G S 124/2023 - APPENDIX G - COMMENTS

CITY OF WINDSOR - ENGINEERING – AMY KUREK

We have reviewed the subject Rezoning application and have the following comments:

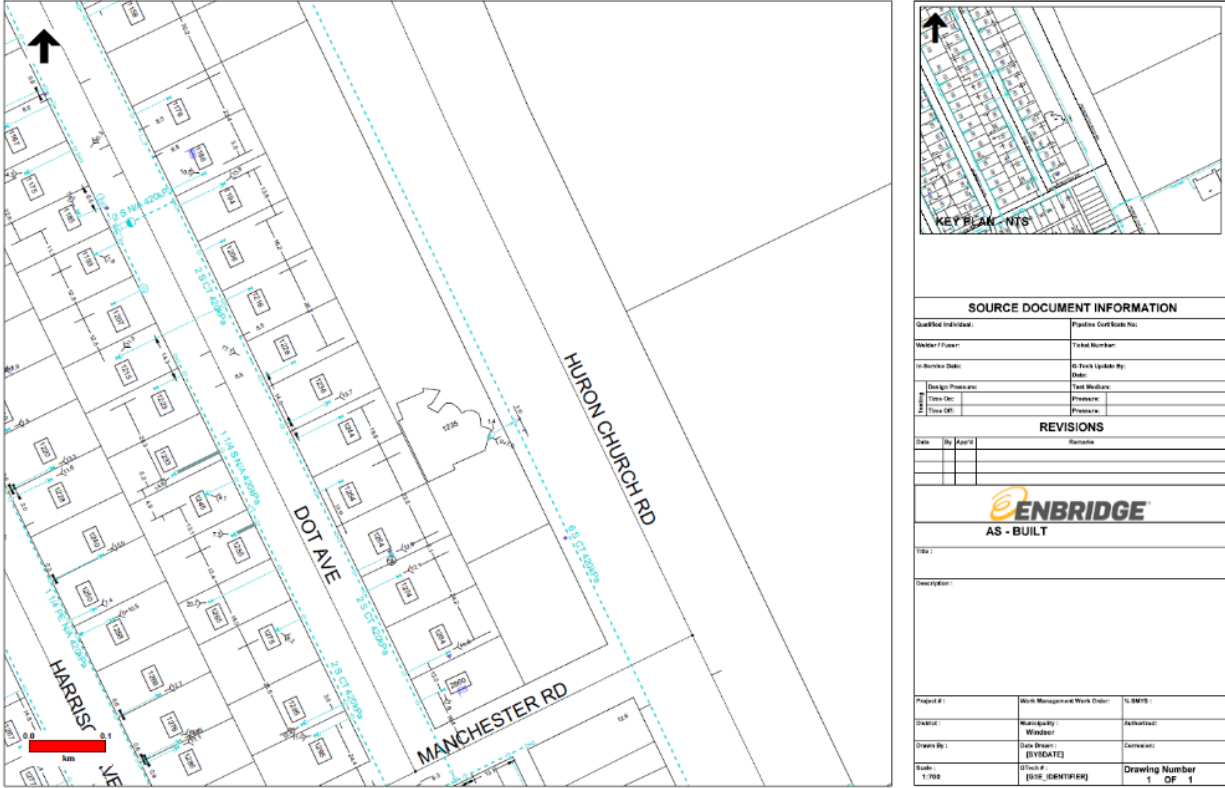
After reviewing the provided drawing at 1235 Huron Church Rd and consulting our mapping system, please note that Enbridge Gas has active infrastructure in the proposed area.

Enbridge Gas requires a minimum separation of 0.6m horizontal and 0.3m vertical from all of our plant less than NPS 16 and a minimum separation 1.0m horizontal and 0.6m vertical between any CER-regulated and vital pipelines. For all pipelines (including vital pipelines), when drilling parallel to the pipeline, a minimum horizontal clearance measured from the edge of the pipeline to the edge of the final bore hole of 1 m (3.3 ft) is required. Please ensure that this minimum separation requirement is maintained, and that the contractor obtains locates prior to performing any work and utilizes safe excavation practices while performing any work in the vicinity.

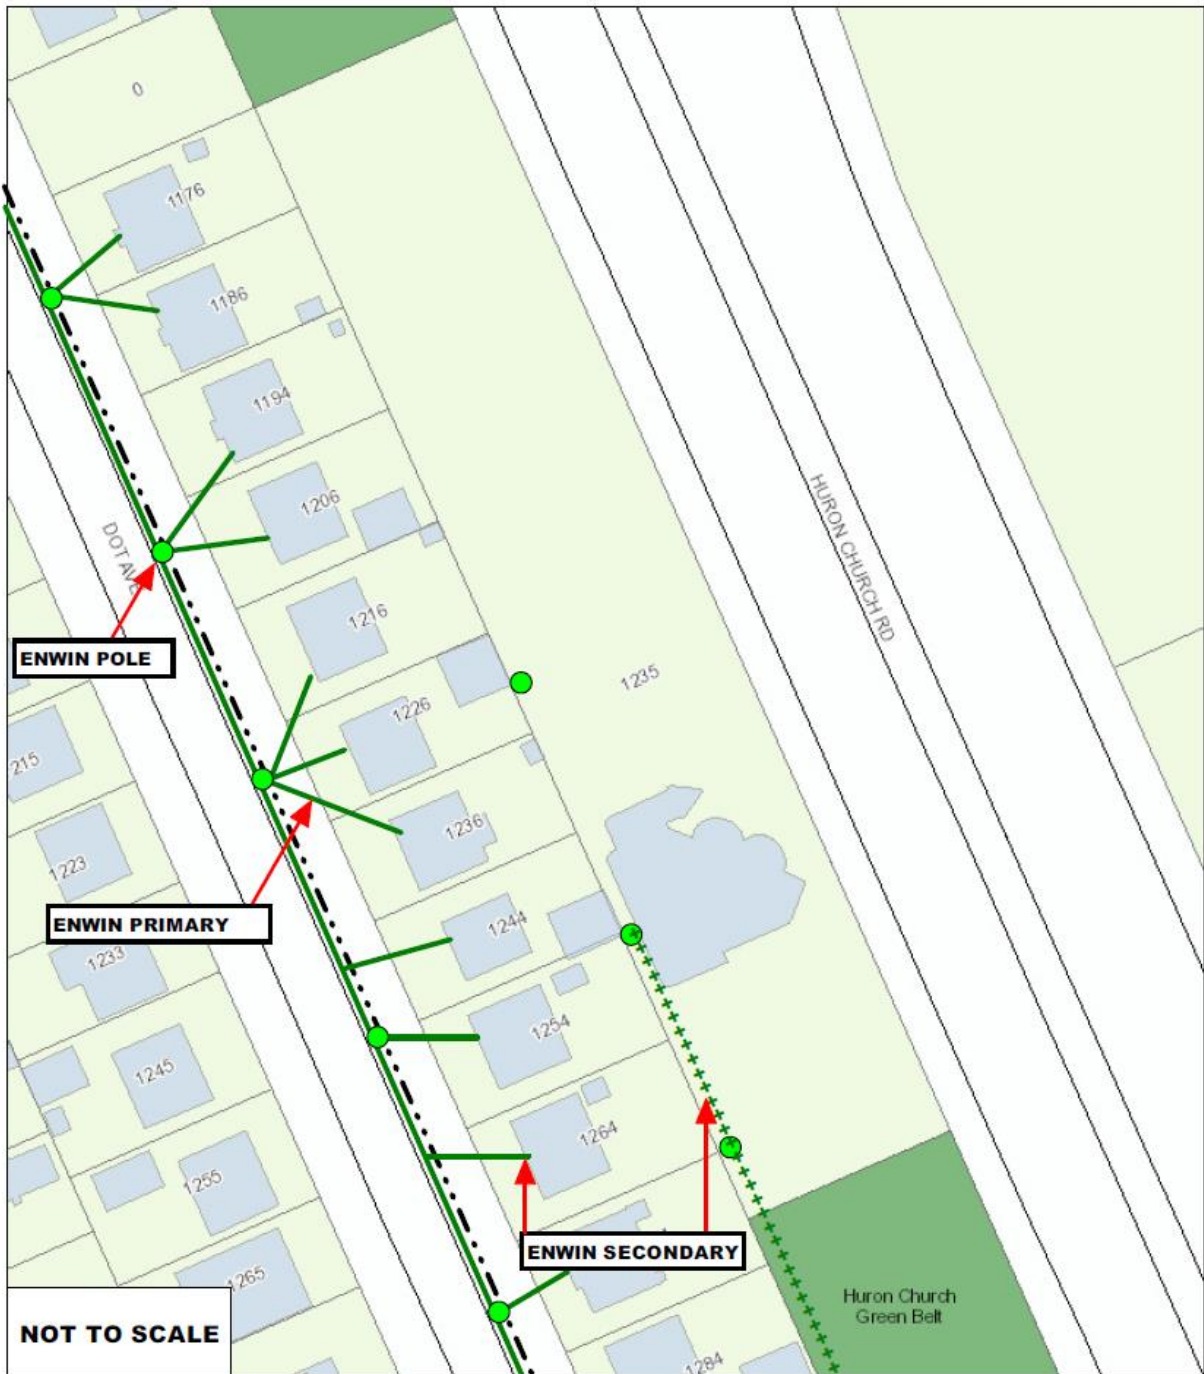
- 1- ENWIN has 120/208V overhead secondary conductors from the southwest corner of the property along the pole line to the existing building.

Prior to working in these areas, we would suggest notifying your contractor and referring to the Occupational Health and Safety Act and Regulations for Construction Projects to confirm clearance requirements during construction.
